Design Review Committee Meeting

April 15, 2020 6:00 PM

PLANNER'S REPORT

TO: Tonya Hutson
FROM: Michael Smith
RE: Mural – 845 North Central Avenue
DATE: March 12, 2020

1 1/4" = 1'-0" BUILDING 1 - NORTH ELEVATION

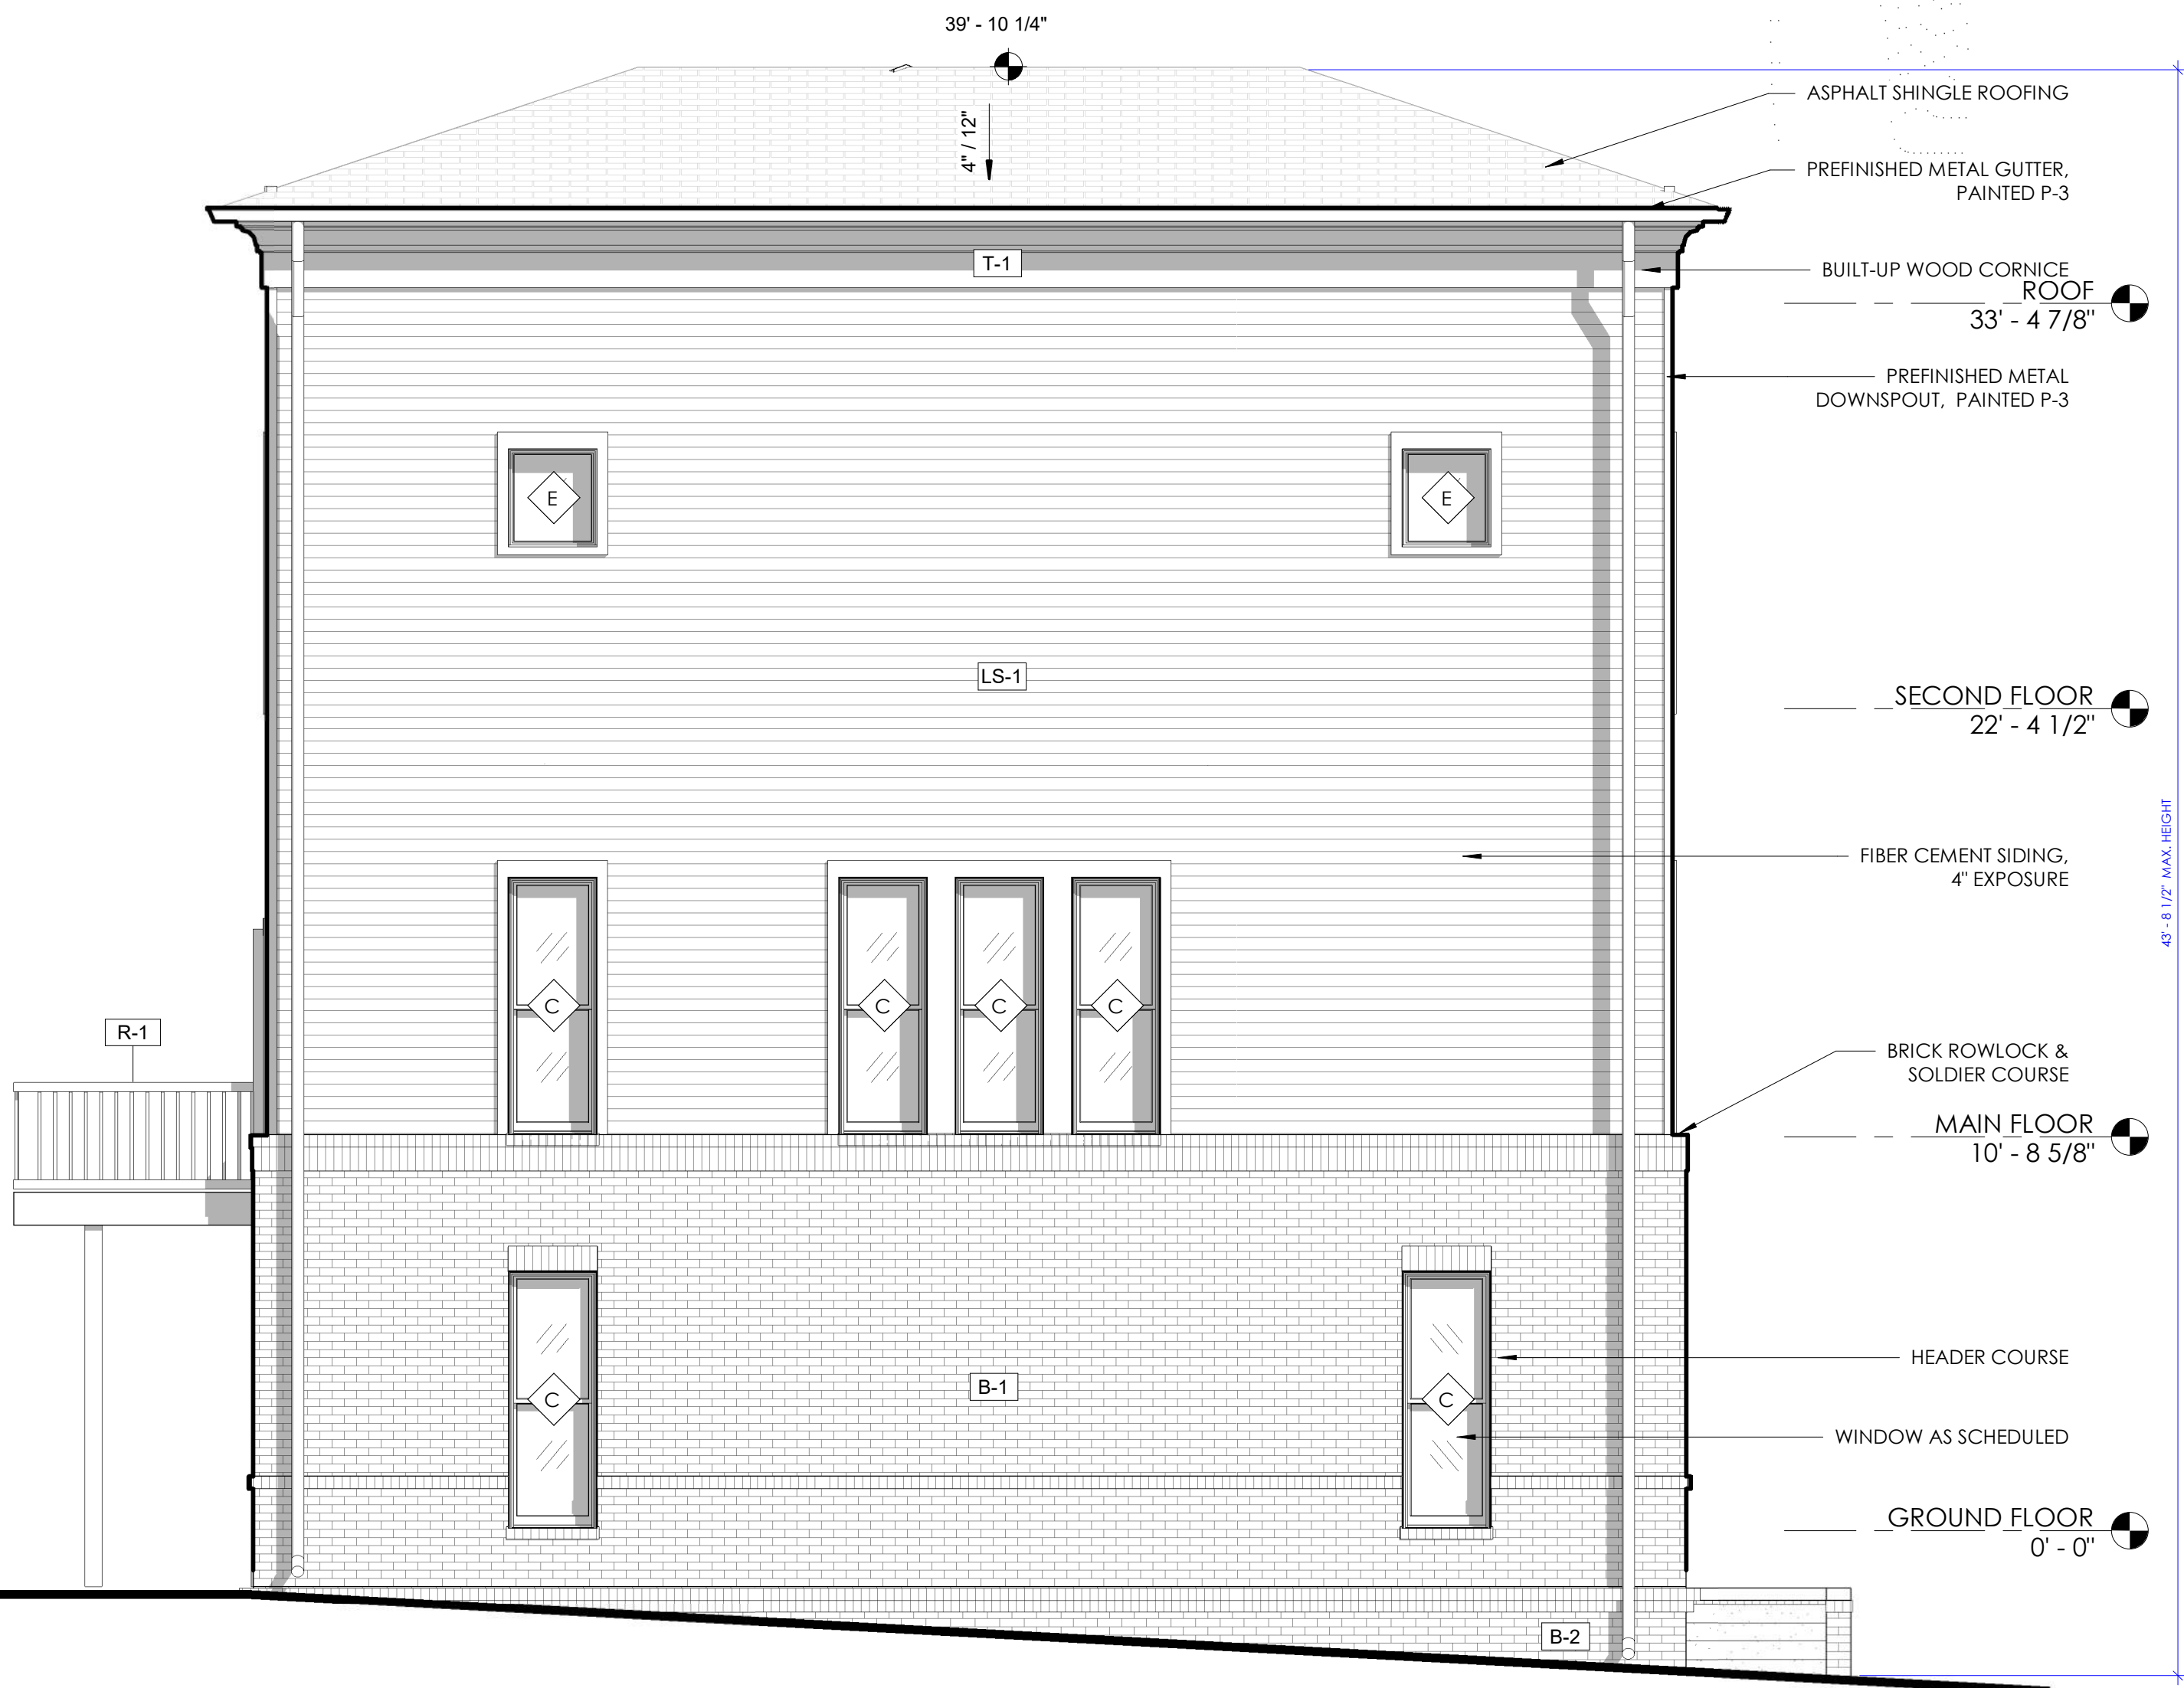
- Blank, windowless walls are prohibited along all facades. The uniform garage doors create a windowless façade at ground level. The applicant should install garage doors with transoms.
- The applicant should clarify the height of the stoop landings above grade.
- The applicant should provide the depth of the stoops.
- The proposed balcony railings must comply with the top and bottom wooden railing requirements of the Standards. The top railing shall consist of two elements. The upper element shall measure two [inches] by six inches and the lower element shall measure two [inches] by four inches. The bottom railing shall measure two [inches] by four inches.
